December 2017

COLUMBIA CLASS SUBMARINE

Immature
Technologies Present
Risks to Achieving
Cost, Schedule, and
Performance Goals

Figure 11: GAO Assessment of Maturity of Columbia Class Critical Technologies (as of November 2017)

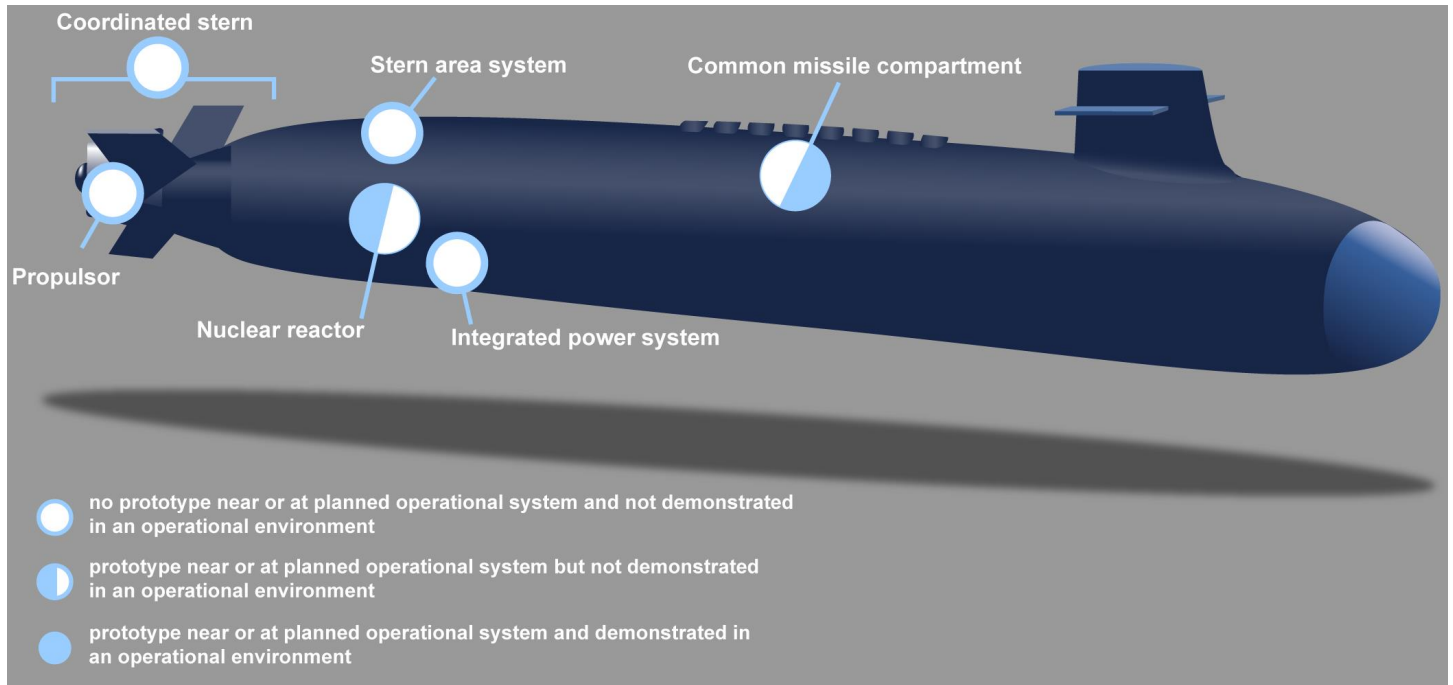
The nuclear reactor, IPS, propulsor and coordinated stern, and SAS all have potentially significant effects on design and construction of the Columbia class because they encompass much of the design and physical structure of the submarine. Based on our analysis, we found that IPS, SAS, the propulsor and coordinated stern are not yet at a TRL 7, as depicted in figure 11. The nuclear reactor and CMC are further along in prototyping work but still require testing in an operational environment to achieve a TRL 7.

If any of these systems do not develop as planned, the Navy and the shipyards could be required to complete some redesign, or, if risks manifest later, they may force costly workarounds or construction rework. In addition, these systems also enable many performance attributes ranging from weapon launch to speed and maneuverability, so performance could be negatively affected. The status of these technologies is discussed in detail below.

Figure 12: Concurrency of Navy Technology Development and Detail Design and Lead Ship Construction

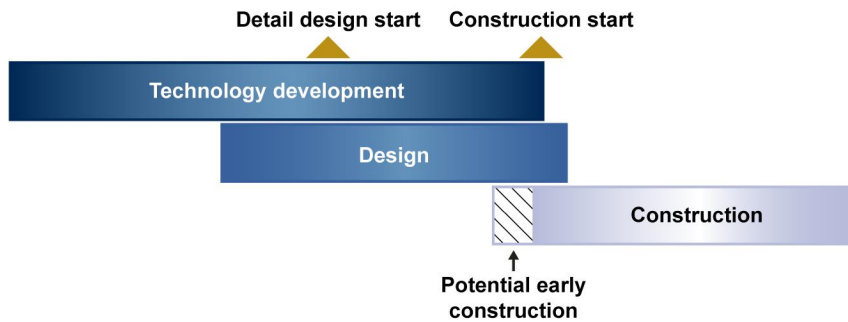
As shown in figure 12, the Columbia class program has entered the detail design phase with a number of technologies still in development or design finalization, which means that the VFI/GFI for these systems are not yet final. This figure also depicts our recommended knowledge points for shipbuilding programs, which align with contract award for detail design and the start of lead ship construction. The concurrency depicted

As is shown in figure 12, the Navy plans to continue technology development while executing detail design; this concurrency may potentially extend through construction if the Navy pursues its plans for early construction. For example, the Navy and the shipyards are currently designing the stern of the submarine—with 95 percent of stern arrangements planned to be complete by December 2017—but the final configuration of the propulsor has yet to be determined. As currently planned, the Navy will not complete prototype testing until the third quarter of fiscal year 2020, and development and design of the SAS is planned to continue until the end of fiscal year 2021—almost a year after the start of lead ship construction. The Navy believes it is managing this stern risk by controlling the interfaces through an Interface Control Document that identifies set design constraints. According to Navy officials, all aspects of the propulsor design that could impact the overall ship design such as size, weight, and arrangements of major sub-assemblies of the propulsor are already finalized, and that the systems are currently tracking to the reservation allowances. However, until a final representative prototype is tested as a system, the possibility of design

changes and broader design impacts remains. Although the Navy plans to have arrangements for the stern 100 percent complete at construction start, the VFI or GFI for these important systems will not be finalized until later after these systems finish development.

Figure 14: Plans for Early Start of Lead Columbia Construction Focus on Critical Areas

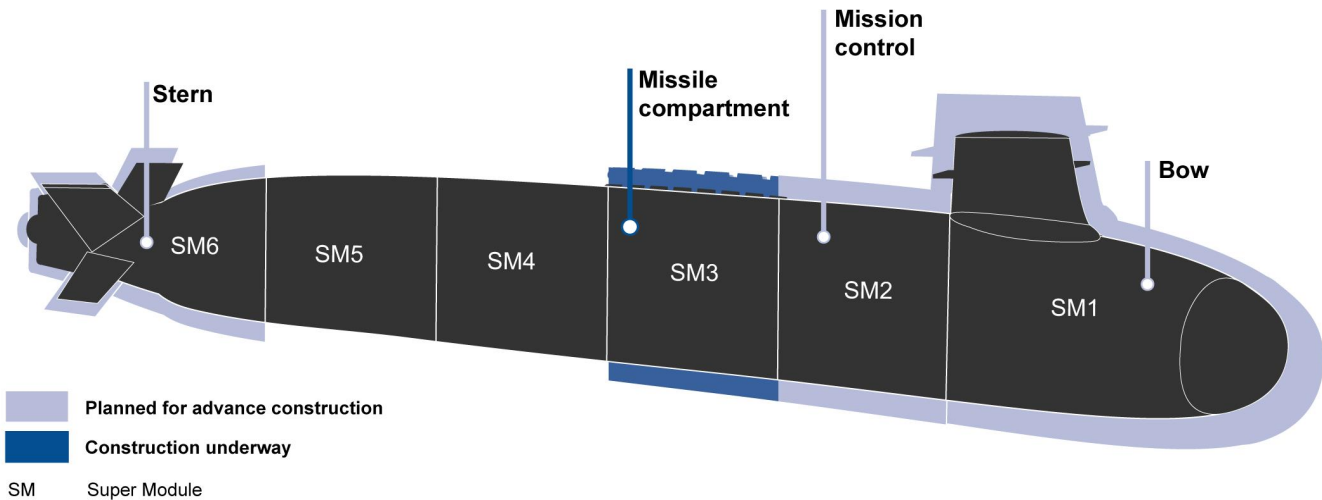
However, the Navy has yet to finalize or fund the approach for this type of early work. Starting construction early for the lead and follow submarines provides schedule relief to the Navy and shipbuilders, but these plans may further exacerbate the existing overlap of technology development and design and construction, which was discussed above. Moving construction earlier could challenge the Navy’s goal to have all components developed 7 months before they are required in the shipyard. Further, the shipbuilders acknowledged that early construction

plans will result in increased overlap between various stages of design activities in certain areas, including the bow and stern. If Congress funds the Navy's plans to fund advanced construction work, this incomplete VFI/GFI situation will likely be worsened and could disrupt the optimal build strategy.
